Service Bulletin

Date: October 2, 2014

Bulletin No: JC-022-12REV1B **Updated to include kit for 72" Non-Generac Units** (highlighted in yellow below)

Product Type: G, H & J series Predator and Predator Pro

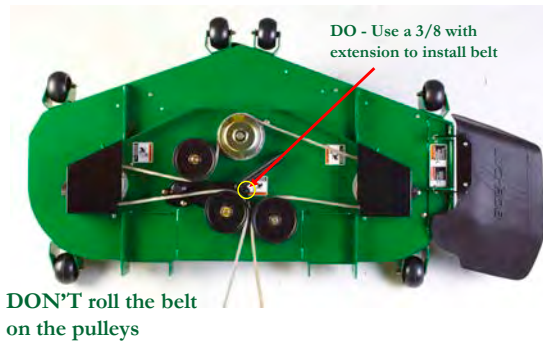
Customer Issue: Premature deck belt failure. (Belt failing in the initial 100 hours of use.)

Cause: Idler spring tension too high, clutch engagement too abrupt.

IMPORTANT: Do **NOT** roll the belt on to the pulleys. You **MUST** put a 3/8" drive breaker bar in the square hole of the idler arm to pull against the spring to allow installing the belt without having to roll it on.

CLARIFICATION: If you roll a belt on a pulley when it has a lot of tension, as in this application, it fractures the cords inside the belt. Therefore belt life will be greatly reduced as a direct result of this damage.

Action Required: For units that experience premature belt failure, install idler belt kit **970488** for 52" units, **970497** for Generac powered 61" units, **970481** for all other 61" units and **970510** for non-Generac powered 72" units. (It may be required to send failed belt back to the factory for warranty approval.)

- 1 revised idler assembly with fixed belt guide
- 1 Stronger cord belt (27% higher tensile strength than original belt). **Note:** Unlike the other previously released kits, the belt in the 72" kit (4170172) is shorter than the original belt (4165645).
- 1 lighter tensioned spring (this is the same spring 4168493 with the yellow stripe issued earlier)
- 1 newly programmed soft start clutch module with harness (even if the unit already has a soft start clutch module on it, you will still need to install the new one)
- 1 new spring anchoring plate as adjusting the spring tension is critical to long belt life.

FIGURE 2

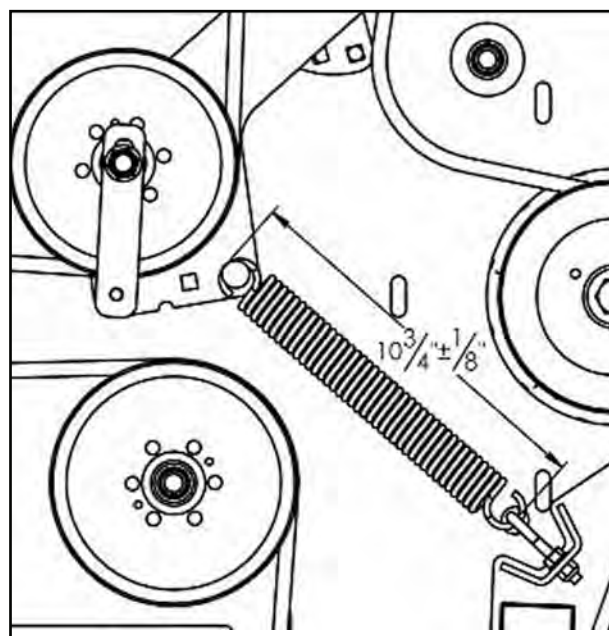
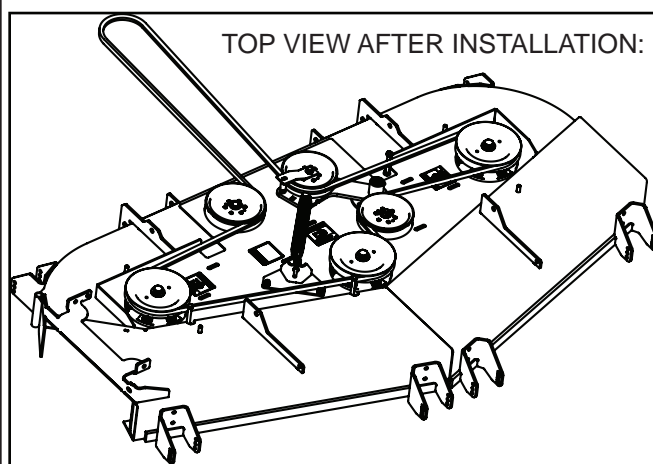
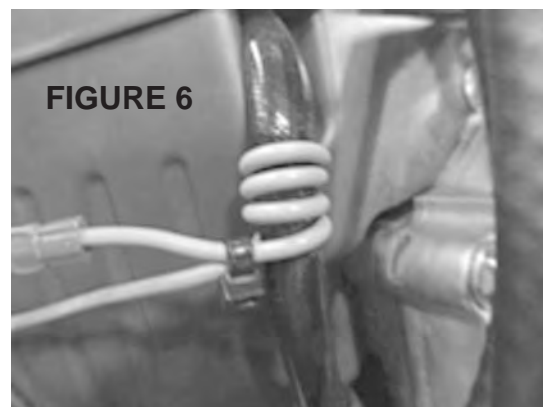
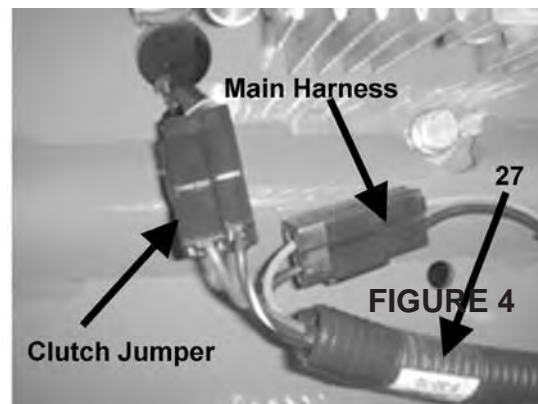
3. Cut out the supplied template (4170167). Orient it on the deck according to Figure 1. Use the template to mark the locations to drill two 3/8" holes for the idler spring mounting plate. Drill the holes.

7. While holding the eyebolt and the spring, tighten the lock-nut on the eyebolt until the distance between the outside of the spring post on the movable idler and the inside of the eyebolt is $10\frac{3}{4} \pm \frac{1}{8}$. Tighten flange nut to lock in setting. **NOTE:** The belt and spring must be installed per step 6 to do this step.

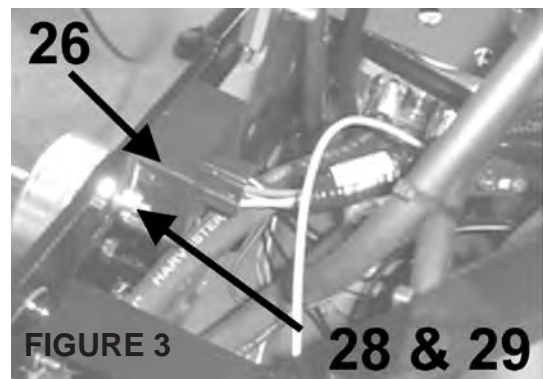
8. Re-install the belt covers with the hardware retained in Step 1.
9. Bolt the soft start module (26) to the left rear bumper support using the 8-32 machine screw and nylon lock nut (28) & (29). There are holes for the screws in the bumper strap. **Figure 3**

NOTE: If your machine has soft start already, change the soft start module to the one included in the kit.

I.S.-KIT, IDLER REPLACEMENT ZT2 72" G & J SERIES (970510)

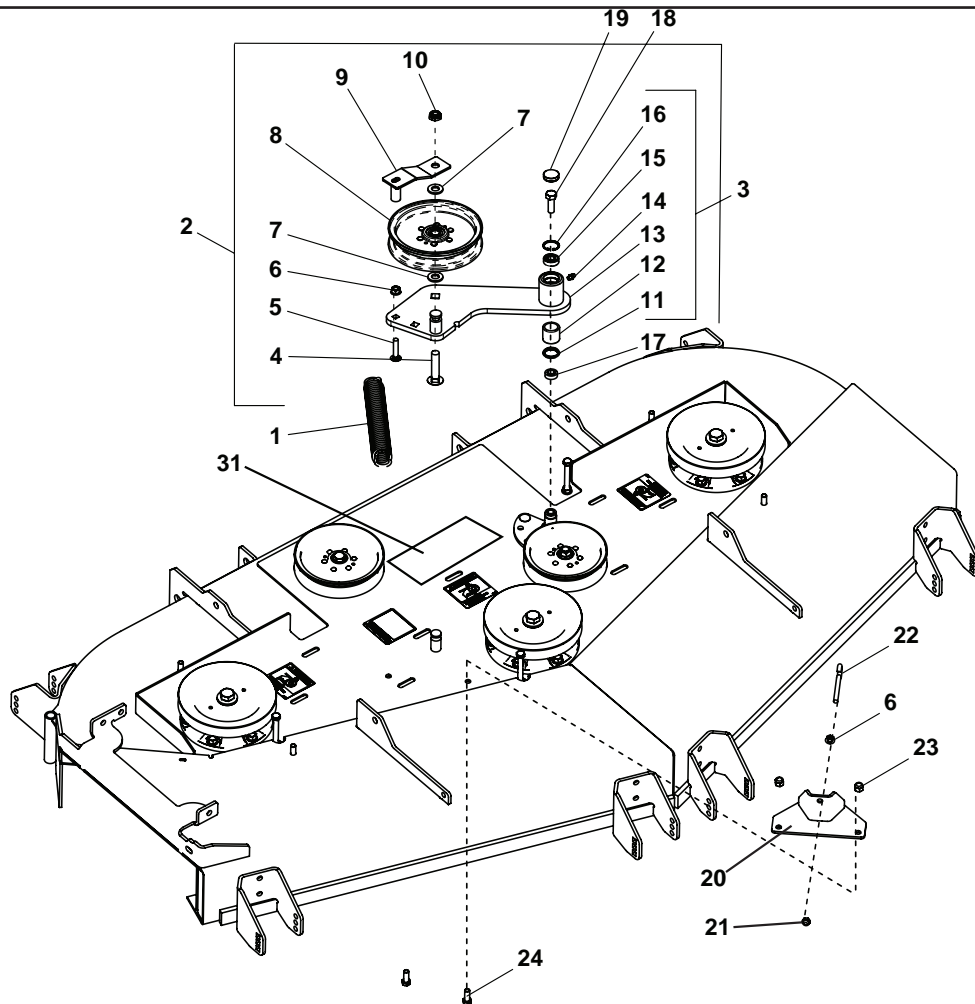
INTRODUCTION: This kit is intended to upgrade the 72" G and J series Predator Pro and ProCat non-Generac models for deck belt failure due to the idler spring tension being too high.
